SUBJECT: Forwards response to 970528 RAI re core spray weld flaw evaluation. Plant-specific sys & risk assessments, provided.

**BROWNS FERRY NUCLEAR PLANT (BFN) - UNIT 3 - RESPONSE TO
REQUEST FOR ADDITIONAL INFORMATION REGARDING CORE SPRAY WELD
FLAW EVALUATION (TAC NO. M98059)**

ENCLOSURE
BROWNS FERRY NUCLEAR PLANT - UNIT 3
RESPONSE TO REQUEST FOR ADDITIONAL INFORMATION REGARDING
CORE SPRAY WELD FLAW EVALUATION

FIGURE 1
DIAGRAM OF ATTACHMENT OF CORE SPRAY PIPE TO SHROUD

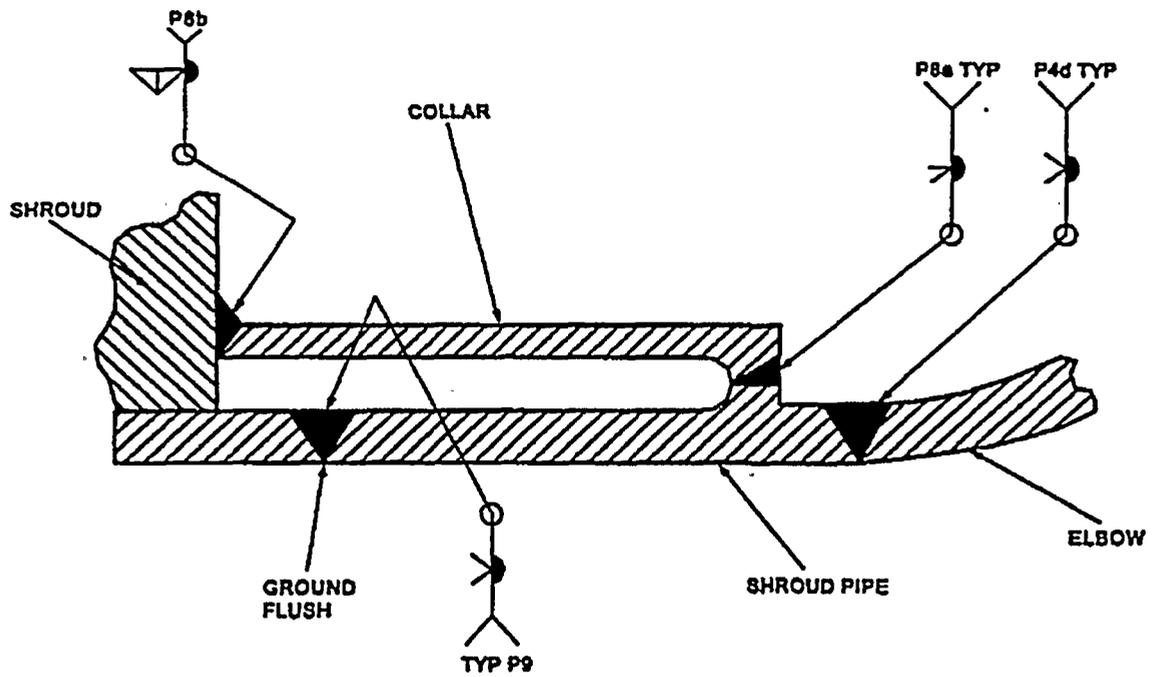
1. Provide a plant-specific system assessment assuming complete failure of weld P9 considering that the structural integrity of weld P8 is not assured.

With respect to the structural integrity of weld P8b, as discussed in TVA's March 9, 1997 letter (Reference 2), the ultrasonic testing (UT) data show the indications on weld P8b (See Figure 1) to be located in the heat affected zone of the core shroud itself, rather than in the collar. Only for the purposes of conservatively evaluating the capability of the core spray piping for continued operation, was a bounding assumption made that the indications are located in the collar. The projected remaining ligament for weld P8b at the end of the cycle of operations showed a projected remaining ligament of 2.5 inches, which would provide axial load carrying capability. With this amount of ligament remaining, the weld would not have any significant moment carrying capability. However, it is likely axial forces would be resisted up to the capacity of the remaining weld.

Finite element modeling was performed by assuming that the connection of the line to the shroud had no moment carrying capability. For the most limiting load cases, the safety factor was found to be greater than five as defined by load capacity/axial load.
